CENPS-OP-TS

MEMORANDUM FOR RECORD

July 3, 1996

SUBJECT: DETERMINATION OF THE SUITABILITY OF DREDGED MATERIAL FOR THE PORT OF EVERETT STAGE I MARINE TERMINAL IMPROVEMENTS PROJECT FOR DISPOSAL AT THE PSDDA PORT GARDNER OPEN-WATER NONDISPERSIVE SITE.

Figure 1 Dredging project characterized in 1993.

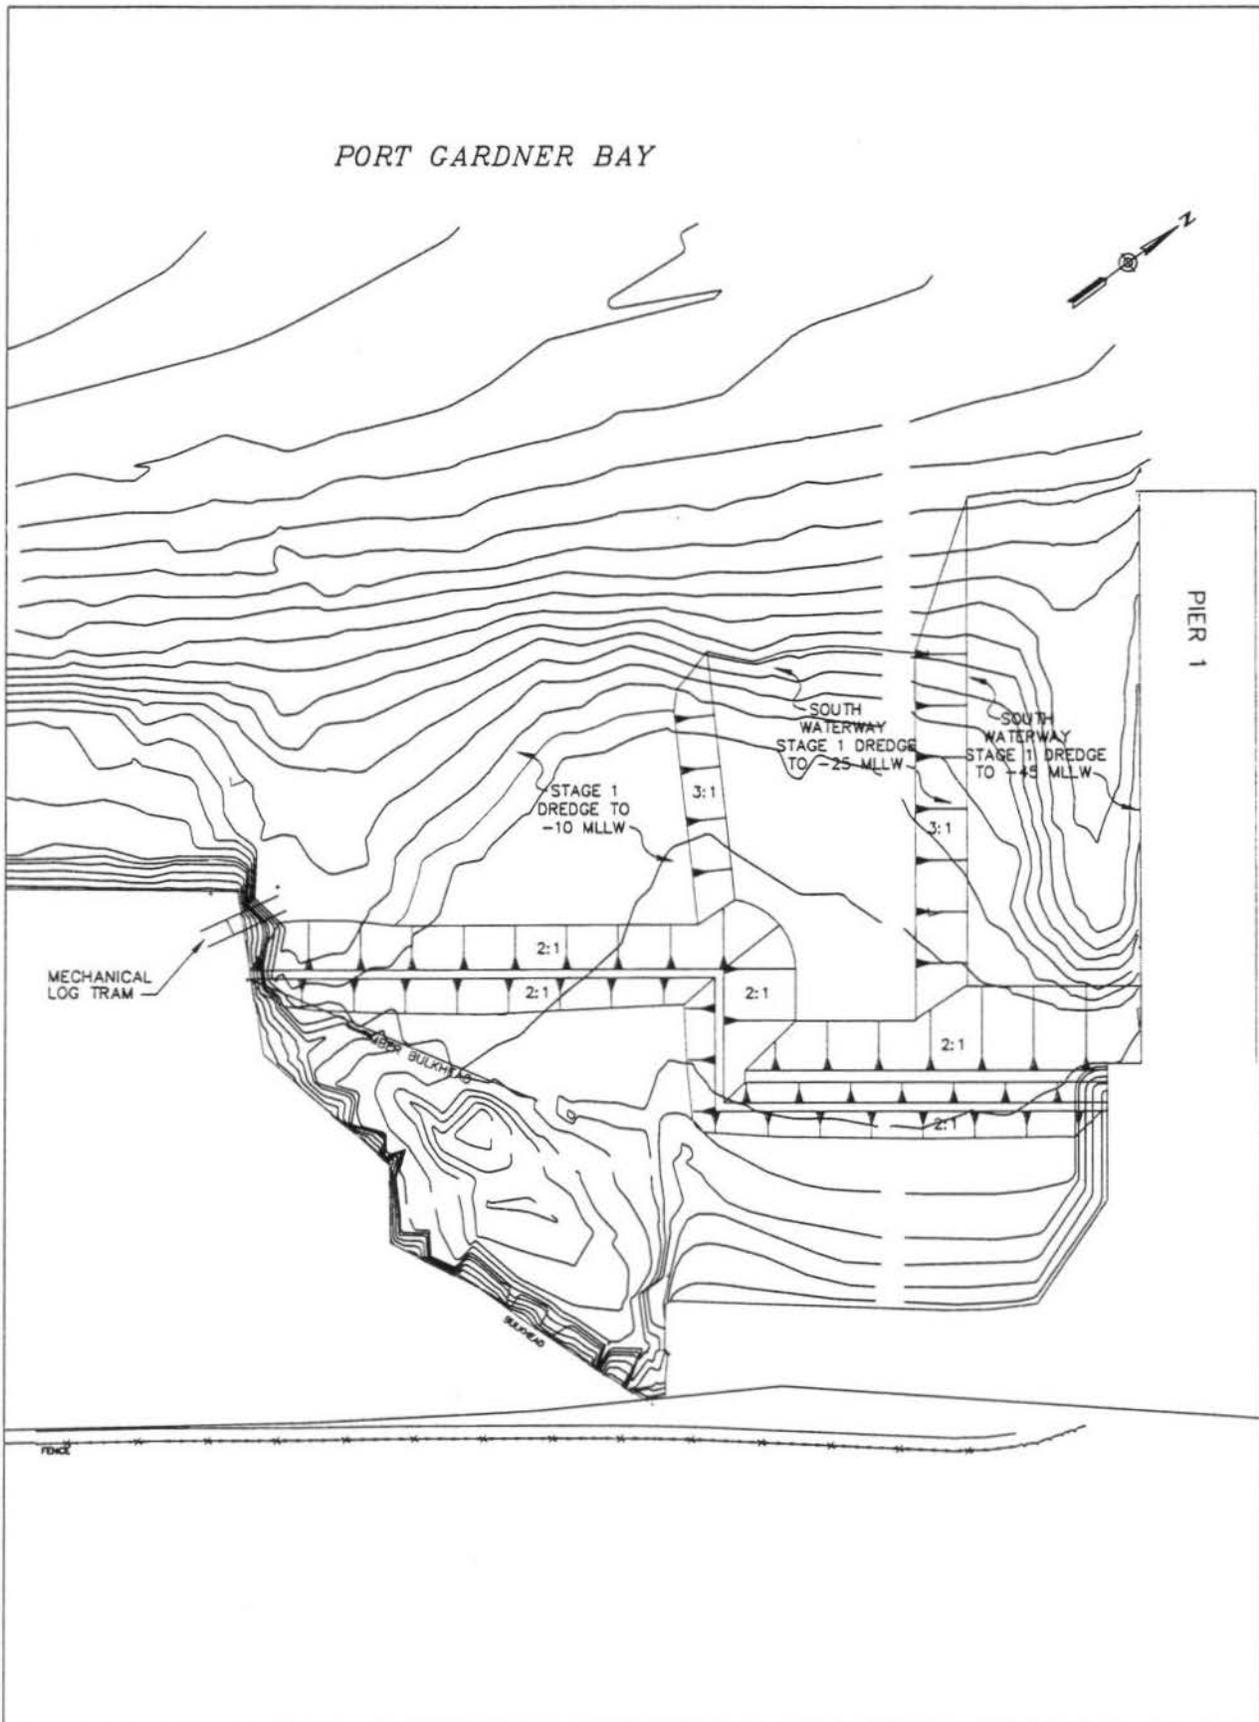
Figure 1 shows the project for which the characterization was conducted and on which the Suitability Decision was based. The project included dredging of the Pier 1 South Berth to -45 ft MLLW, dredging in front of the Barge Berth to -25 ft MLLW, and dredging the log handling area to -10 ft MLLW. As detailed in the DMMO's Memorandum of Record (September 9, 1994) for the above-referenced project, all 183,000 cy of sediment to be dredged as part of the project was considered suitable for disposal at the Port Gardner open-water nondispersive site. The 183,000 cy of sediment was comprised of 94,300 cy of wood/silt material and 88,700 cy of underlying native sediment. The wood/silt material was characterized during the PSDDA FC conducted during late 1993. The PC conducted in 1992 determined the native sediment underlying the wood/silt material was suitable for open-water disposal; no testing of the native sediment was required during the FC.

Figure 2 Plan view of dredging areas.

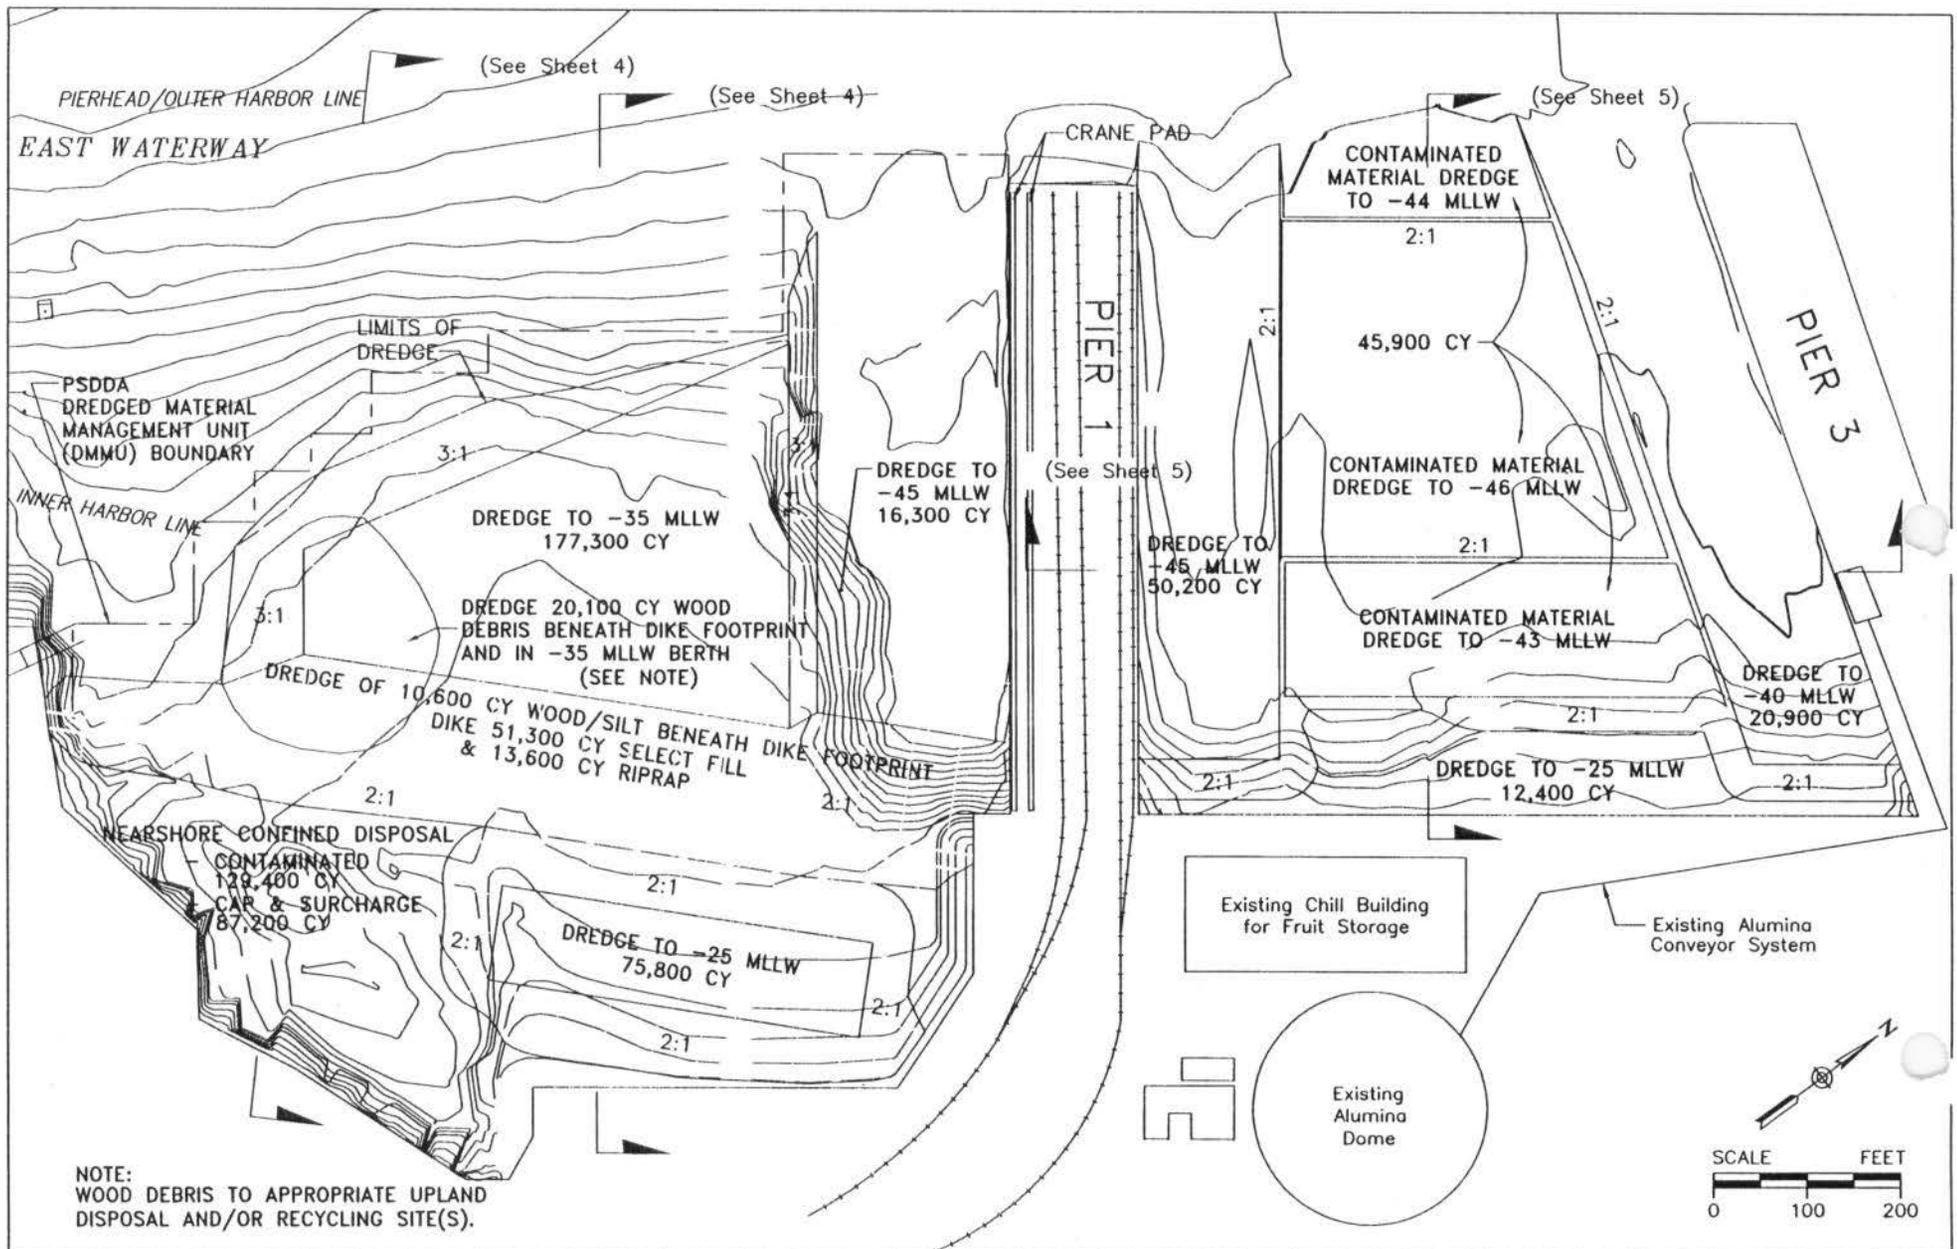
The dredging for the proposed project is shown on Figure 2 (Corps Permit Sheet 3). This project includes dredging of the Pier 1 South Berth to -45 ft MLLW and dredging in front of

the Medium-Draft Facility to -35 ft MLLW. The project will require the dredging of approximately 422,000 cy of sediment. The 422,000 cy of sediment includes the volume of sediment previously dredged from the Pier 1 South Berth in 1995. Table 1 details the volumes by soil unit (wood/silt and native) and dredge area and where the material will be disposed. Figure 2 shows the location of the dredge areas identified in Table 1.

Figure 3 (Sheet 4) shows two typical sections perpendicular to the face of the dike (Figure 2). The deposit of wood debris shown on Figure 2 is not being considered for open-water disposal; all wood debris will be disposed of at an approved upland site or recycled.

Figure 4 Stage 1 - Marine Terminal Improvements South Waterway Area Dredging Plan View.

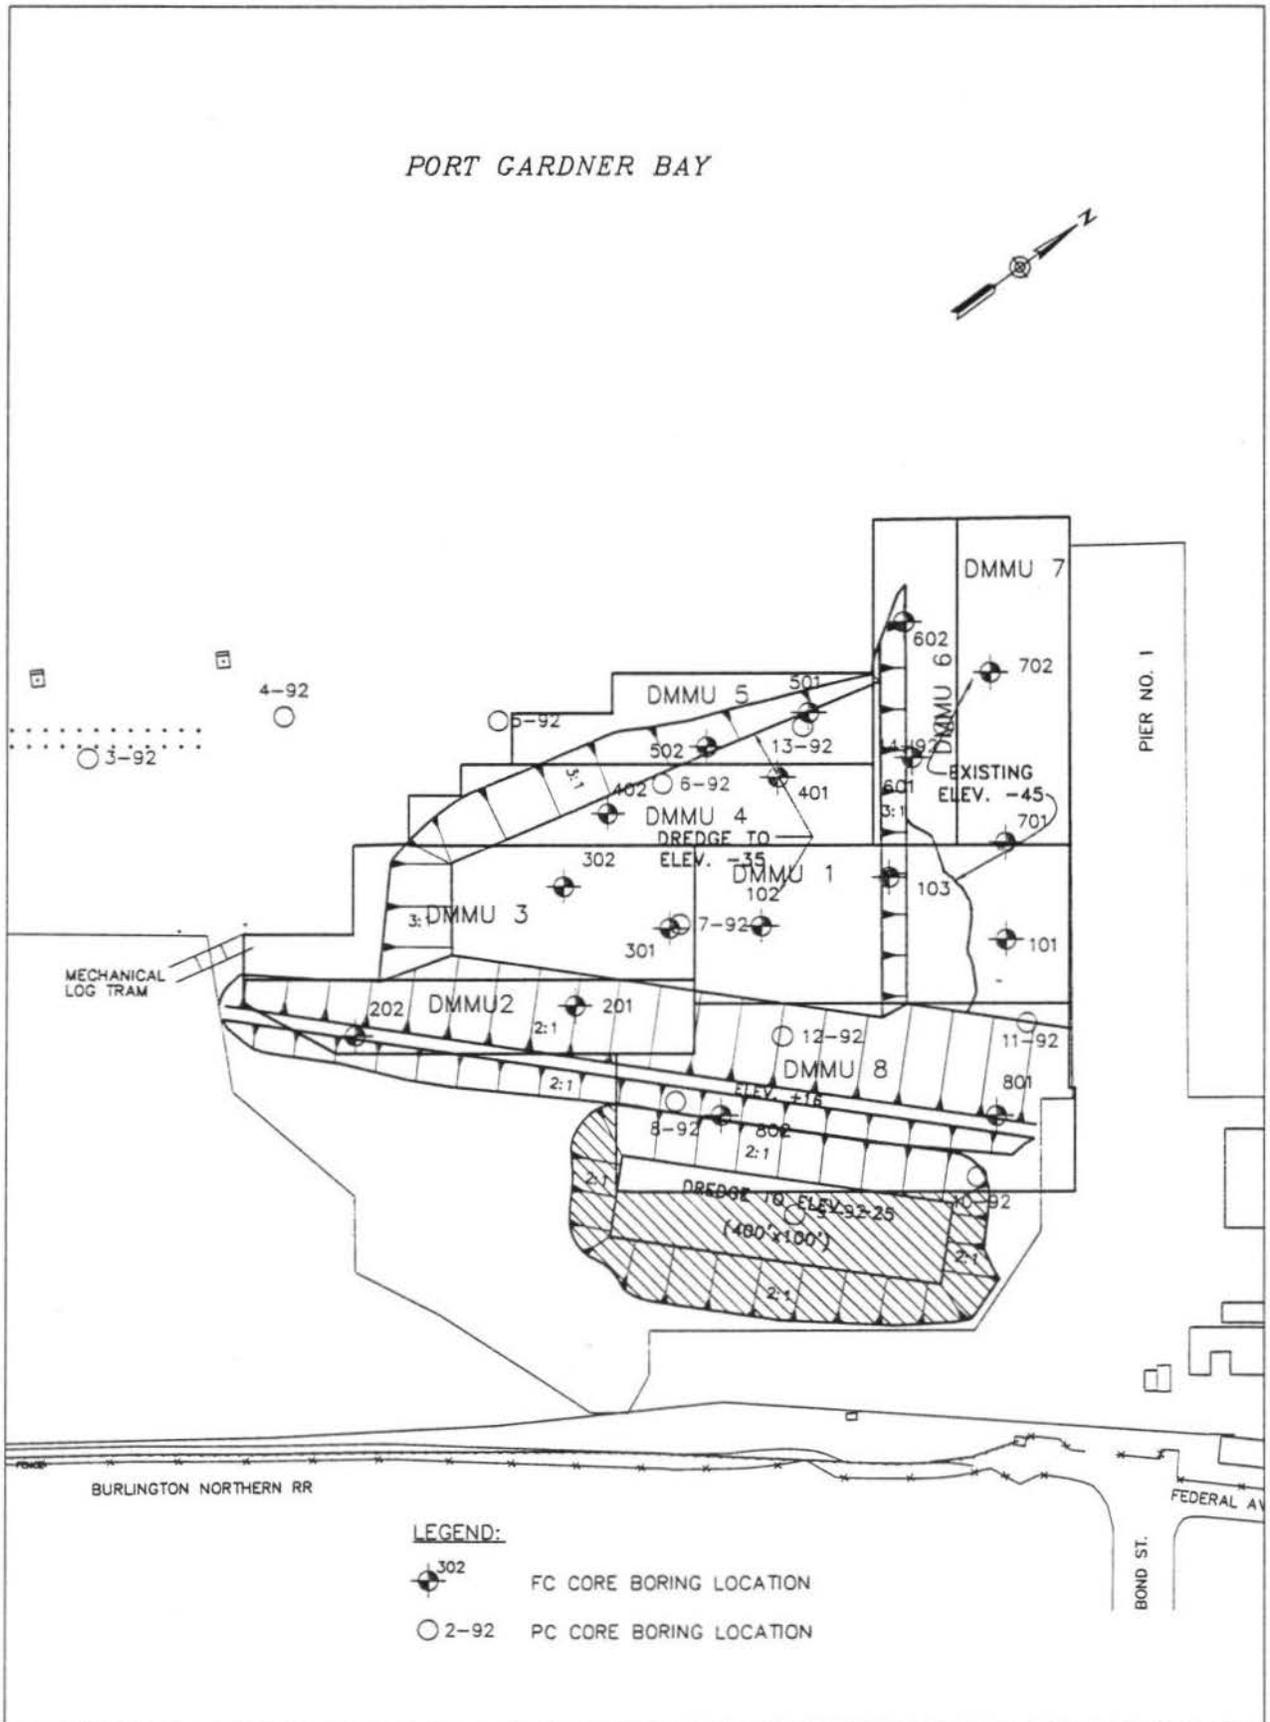
4. The additional volume proposed for dredging under the current plan can be broken into three fractions for purposes of this suitability determination. First, there is additional native material that was not explicitly addressed in the previous determination. Second, as can be seen from Figure 4 of Attachment B, a portion of the nearshore fill footprint falls outside the DMMUs addressed in the previous determination. Finally, a pocket of wood debris underlying the footprint of the dike and medium-draft berth (Figures 2 and 3) has been identified. These three fractions will be addressed under bullets 5, 6 and 7 respectively.

All dredging for the project will be conducted within the footprint of the area previously characterized under PSDDA with the exception of a portion of the area to be excavated behind the dike (Figure 4). The excavation behind the dike will add additional contaminated sediment storage capacity to the fill. This area was characterized as native material with surficial wood debris in the *Site Characterization Report, South Terminal Expansion, Port of Everett Washington* (Dalton, Olmsted, and Fuglevand, Inc., and Pentec Environmental, Inc. 1992).

Three core samples were collected (8-92, 9-92, and 10-92; Figure 4) in the area behind the dike during the PC conducted in 1992. One PC sample (10-92) had one detected and one undetected exceedence of PSDDA SLs (the concentration of pyrene was detected at 560 $\mu\text{g}/\text{kg}$). There was also one undetected exceedence of SLs at Station 8-92 and three undetected exceedences of SLs at Station 9-92. The composite sample collected from DMMU 8 (Stations 801 and 802) from the FC conducted in 1993 had only one undetected exceedence of PSDDA SLs.

a) The two DMMUs (DMMU 2 and DMMU 8) from the full characterization (FC) survey that are adjacent to the new surface material were chemically the cleanest of any of the DMMUs. Neither DMMU 2 nor DMMU 8 had any detected exceedances of screening levels (SLs). Both had a single detection limit exceedance of the SL for benzyl alcohol (25 ppb) with detection limits reported as 38 and 36 ppb, respectively. Both DMMUs passed biological testing.

b) Two samples from the PC fall within the footprint of the excavated area for the nearshore fill. Sampling location 10-92 falls just within the boundary of DMMU 8, while sampling location 9-92 falls nears the center of the proposed excavated area and just outside the boundary of DMMU 8. The surface sediment (0-3.5 feet) analyzed from 10-92 had a single detected SL exceedance (pyrene = 560; SL = 430). Surface sediment (0-2.5 feet) from 9-

92 had no detected exceedances of SL and a single undetected exceedance (benzyl alcohol = 25.1, SL = 25). There were no SL exceedances in subsurface sediment (2.5-6.0 feet) from 9-92.
